Access Compliance Report

Public Rights-of-Way

(Curb Ramps)

Intersection ID: 26711	Main Street: APPLE_TWIG_DR	Cross Street: MANOR_HOUSE_DR	Location:	N
ADA ID: 0DAC1633DDD9	Ramp Type: BlendTrans1	Initial Pass/Fail: Fail	Overall Compliance: No	Severity Score: 12.5

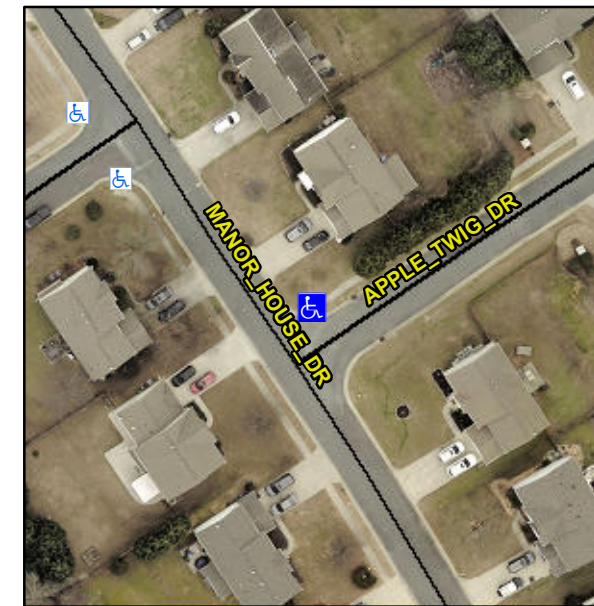
Not Found, R304.5.3

Compliance	Description	Data	Compliance	Description	Data
N/A	Ramp Length (in)	46.0	Yes	BlendTrans Slope (%)	2.3
Yes	Ramp Width (in)	48.0	No	BlendTrans XSlope (%)	5.6
N/A	Flare Type LT	N/A	N/A	Flare Type RT	N/A
N/A	Flare Slope LT (%)	N/A	N/A	Flare Slope RT (%)	N/A
N/A	Flare Traversable LT?	N/A	N/A	Flare Traversable RT?	N/A
N/A	Landing Length (in)	N/A	N/A	DWS Provided?	N/A
N/A	Landing Width (in)	N/A	N/A	DWS Contrast?	N/A
N/A	Landing Slope (%)	N/A	N/A	DWS Length (in)	N/A
N/A	Landing X Slope (%)	N/A	N/A	DWS Full Width?	N/A
N/A	Landing Curb? (Y/N)	N/A	N/A	DWS Offset (in)	N/A
N/A	Shared Landing?	N/A			
N/A	Gutter Ponding?	N/A	N/A	Gutter Slope (%)	N/A
N/A	Gutter Lip Ht (in)	N/A	N/A	Gutter X Slope (%)	N/A
N/A	Painted X Walk1?	No	N/A	Painted X Walk2?	N/A
	X Walk 1 Direction	To SW		X Walk 2 Direction	N/A
	X Walk 1 Width (in)	N/A		X Walk 2 Width (in)	N/A
	X Walk 1 Slope (%)	2.8		X Walk 2 Slope (%)	N/A
	X Walk 1 X Slope (%)	2.0		X Walk 2 X Slope (%)	N/A

N/A	Ramp inside XWalk1?	N/A	N/A	Ramp inside XWalk2?	N/A
	Road Slope (%)	2.0		Clear Space?	N/A
	Road X Slope (%)	2.8	N/A	Clear Space to XWalk (in)	N/A
N/A	Any Obstructions?	N/A	N/A	Storm Grate/Utility Hazard?	N/A
	Obstruction Type			Storm Grate/Utility Type	
		N/A			N/A
			Yes	Surface Condition? (G/P)	Good
			No	Curb Slope (%)	7.7

Remove & Replace Curb Ramp With Two New Directional Ramps or Equivalent.
